Crosby Greenlake

414 NE Ravenna Blvd

Design Review Board - Design Recommendation Meeting

DPD #3016188

A-5 Diagrams to show increased setbacks and recesses

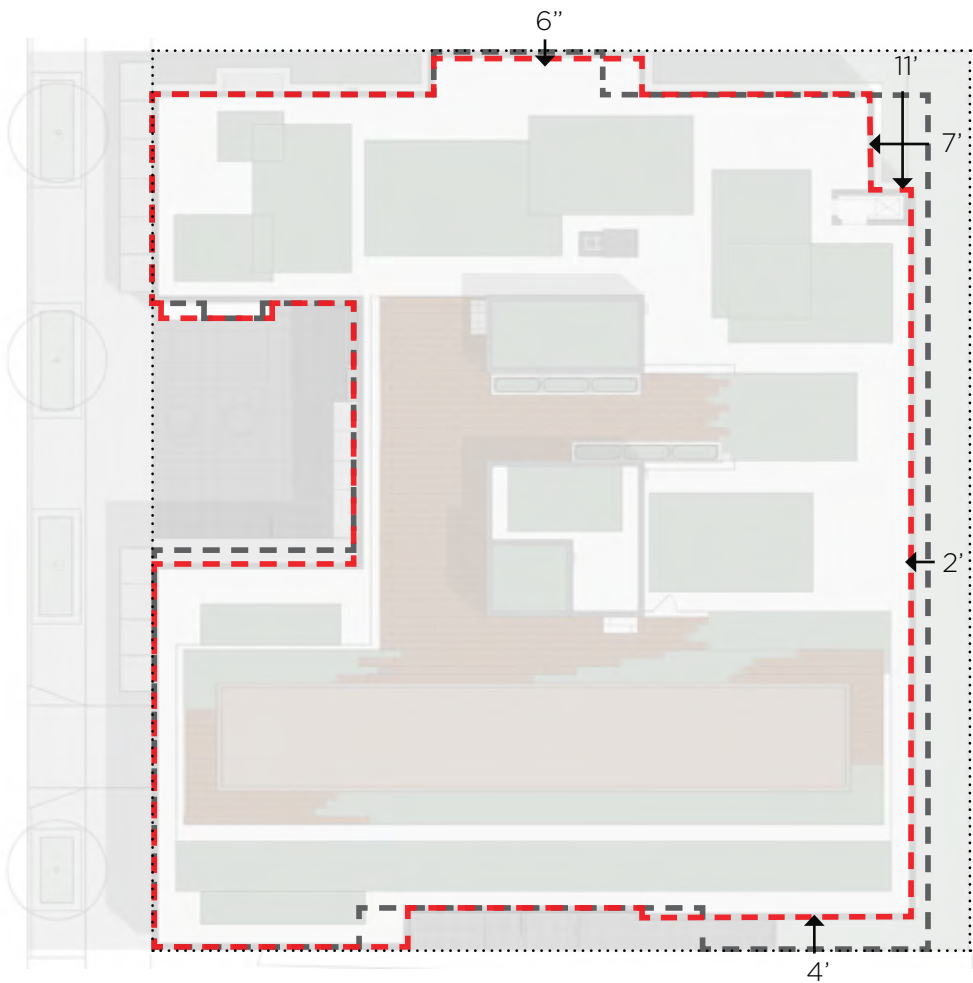
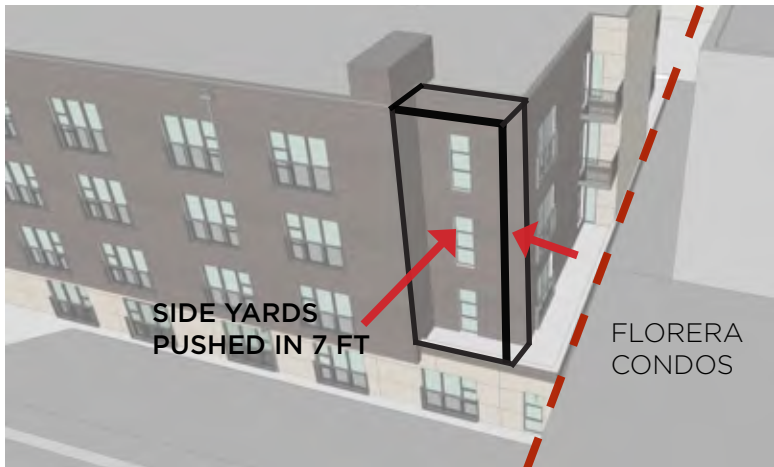
A-5 Respect for Adjacent Sites. Buildings should respect adjacent properties by being located on their sites to minimize disruption of the privacy and outdoor activities of residents in adjacent buildings.

After reviewing the site and vicinity zoning, the adjacent buildings and the proposed massing, the Board requested that the applicant modify the proposed structure at the northeast corner to ensure relief for the adjacent Florera courtyard. See guidance for B- 1.

Applicant Response: *We have increased setbacks on the back yard and side yards from our original proposal. Further, we recessed the northwest corner of our design, the corner that faces the Florera courtyard. Please refer to diagram A-5.*

D-6 Diagrams to show Trash, Bike, and Retail Servicing

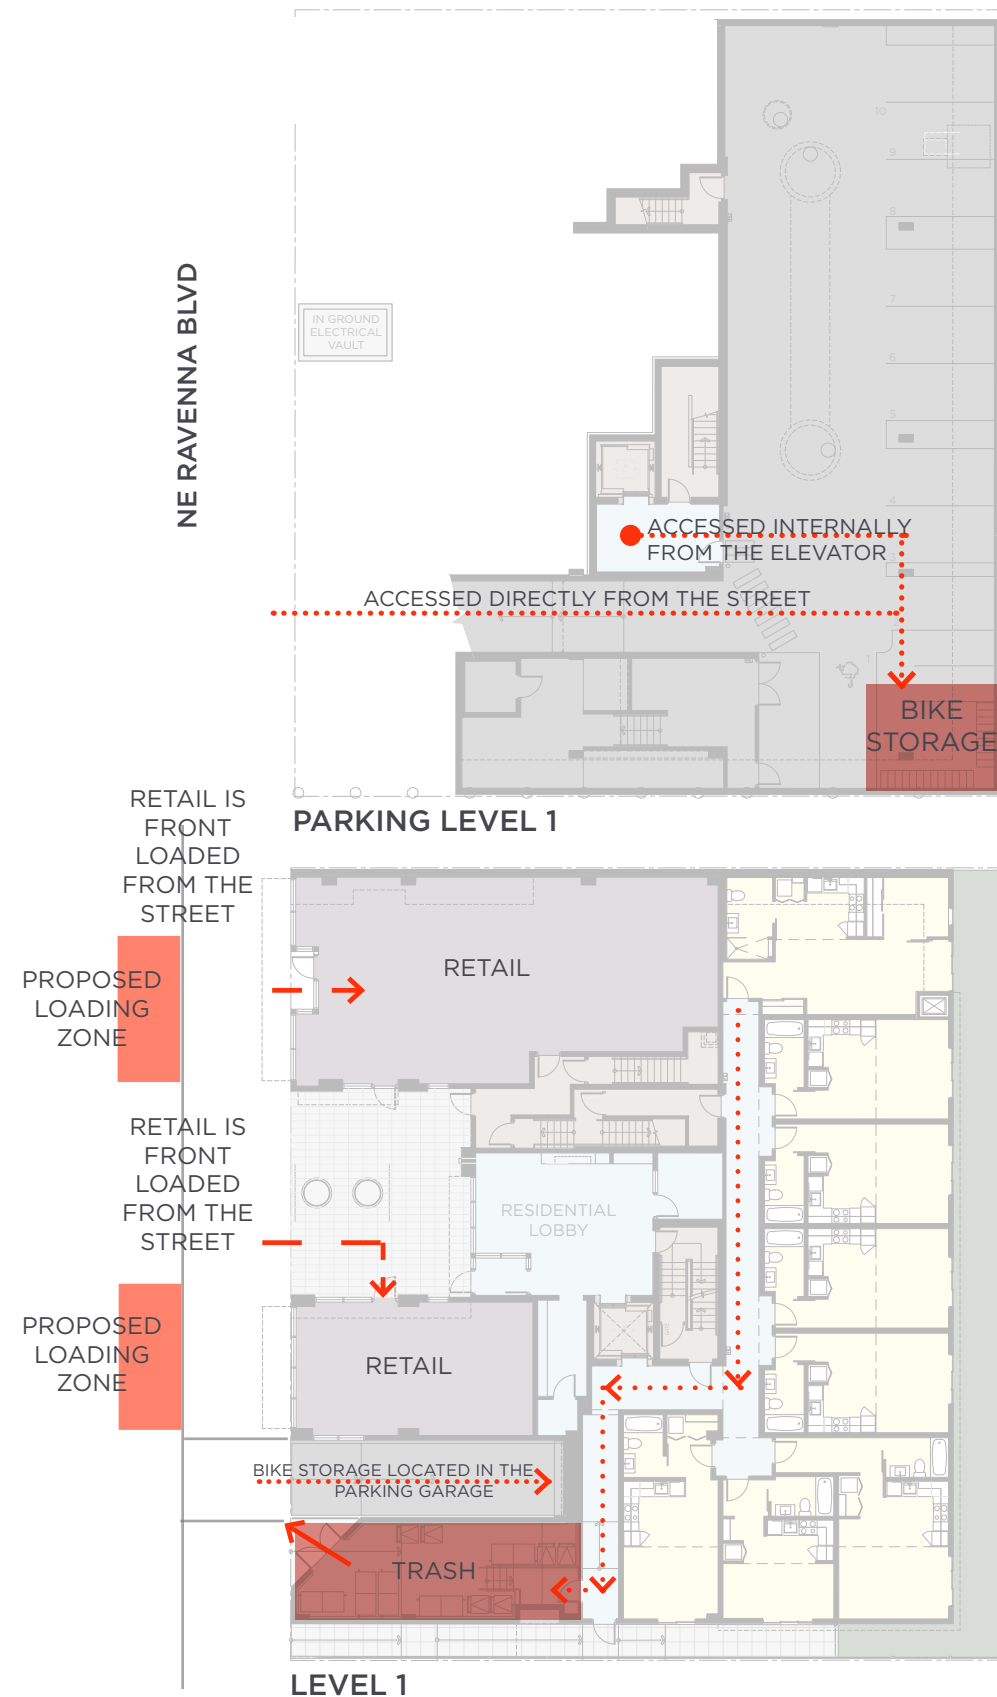
D-6 Screening of Dumpsters, Utilities, and Service Areas. Building sites should locate service elements like trash dumpsters, loading docks and mechanical equipment away from the street front where possible. When elements such as dumpsters, utility meters, mechanical units and service areas cannot be located away from the street front, they should be situated and screened from view and should not be located in the pedestrian right-of-way.

Show the location of the solid waste storage area and diagram how transference occurs. Where will moving vans park? How will tenants access their bikes?

Applicant Response: Please refer to the diagram “D-6 Diagram to show Trash, Bike and Retail Servicing.”
